ElectraNet SA

Murraylink Application for Conversion and Maximum Allowable Revenue

Submission - July 2003

Figure 1: Comparison of Gross Market Benefits and Proposed Revenue Cap

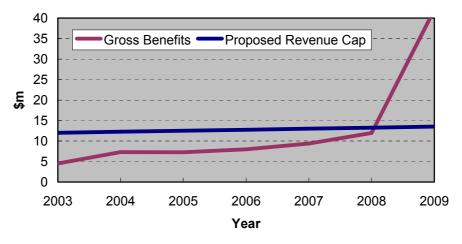
Substituting the lower Riverland deferral benefit of \$1 million per annum in MTC's base case analysis results in total gross market benefits of \$4.5 million in 2003 increasing to \$12 million in 2008.

Not until 2009 does the analysis show gross market benefits exceeding the annual revenue cap of more than \$12 million per annum proposed by the ACCC. This comparison is illustrated in the following figure.

ElectraNet submits that the ACCC should not allow the regulated revenue cap to exceed the gross market benefits of the interconnector or the benefits of conversion to regulated status.

The ACCC should be guided in its assessment by the very low gross market benefits assessed for at least the first five years and estimates of Murraylink's current annual earnings in the market (of the order of \$4-6 million).
